# Addendum #3

The Parkside Neighborhood Center and Affordable Housing Mellen & Grant Streets, Portland, Maine 04101

February 25, 2004

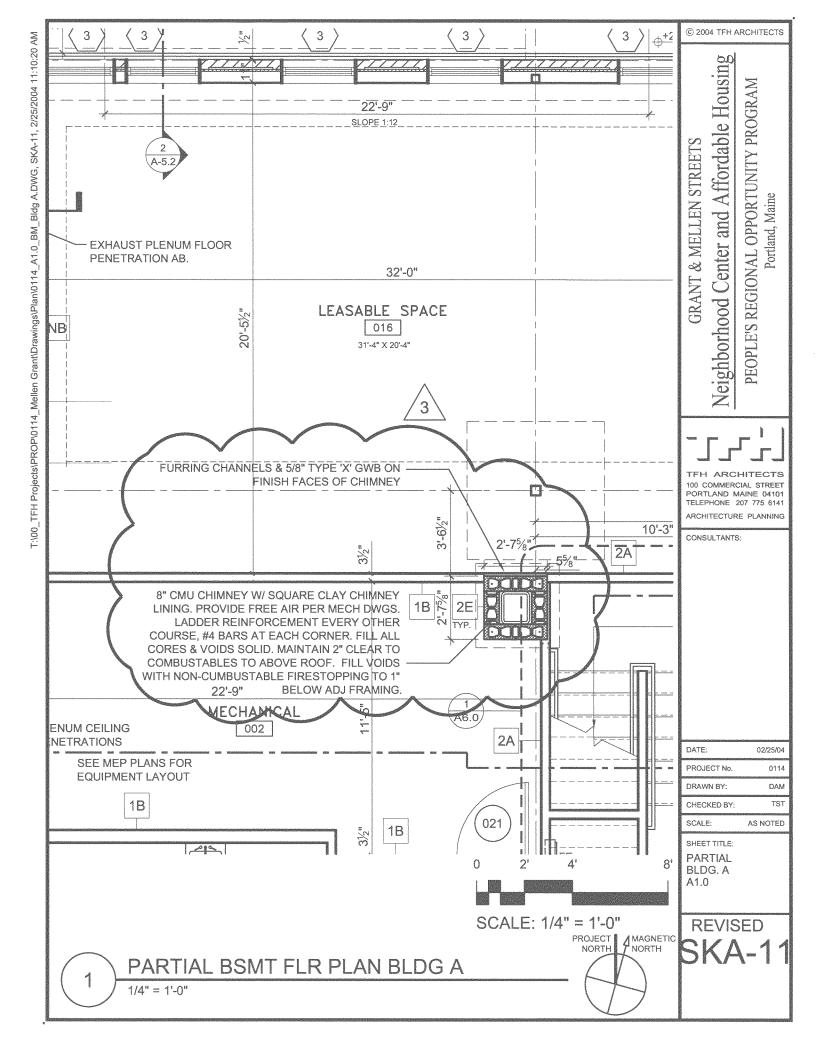
3-8	G-1	Partition Types	REVISE 2 hr partition type '2E' to 8" CMU.	
3-9	A1.0 A	doment of the state of the stat	REVISE chimney with attached revised SKA-11.	
February 25, 2002			PNC & Affordable Housing	Page 2

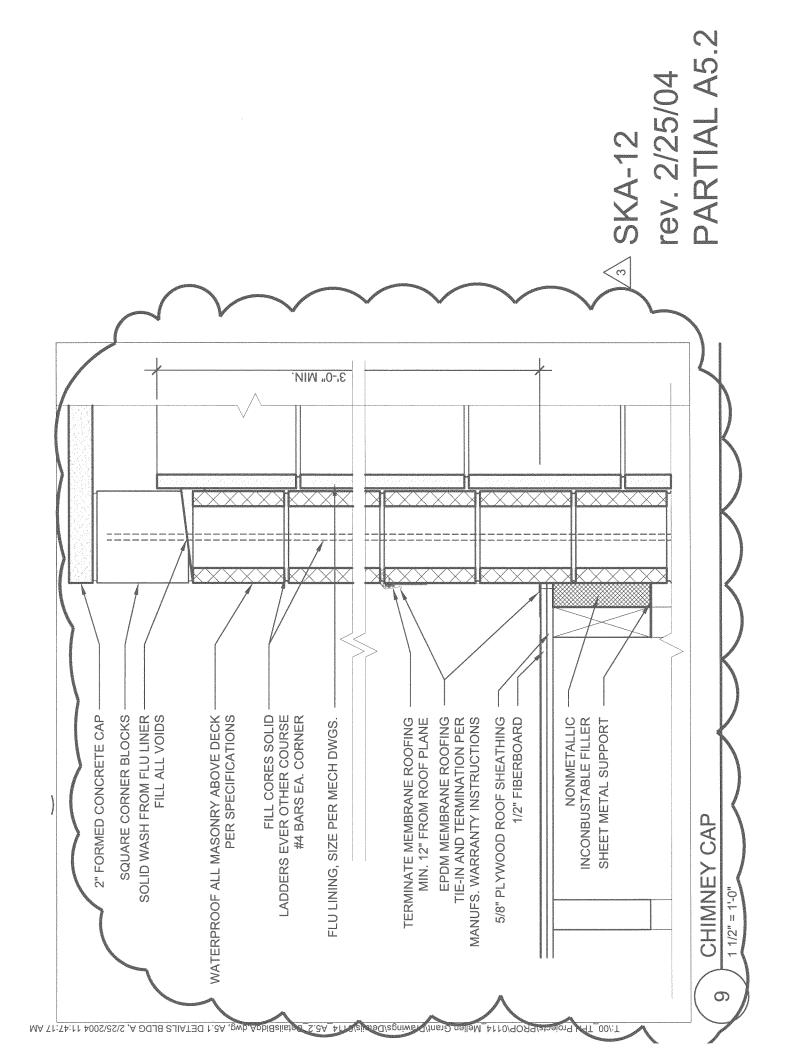
3-10 Al.1 A 1	REVISE chimney with attached revised SKA-13.				
3-11 A1.0 B 1	REVISE chimney with attached revised SKA-14.				
3-12 A1.1 B 1	REVISE chimney with attached revised SKA-15.				
3-13 A5.2 A/B 1	REVISE chimney cap with attached revised SKA-15.				
	TE VIOL CHAMICY COLD WITH ACCOUNTED TO VIOLA DIEVE 10.				
NEW DRAWINGS					
Item Sheet Detail	Description				
None					
Questions & Clarifications					
None					
ARCHITECT'S SUPPLEMENTARY INSTRUCTIONS					
None					
CERTIFICATION					
By:	Date:
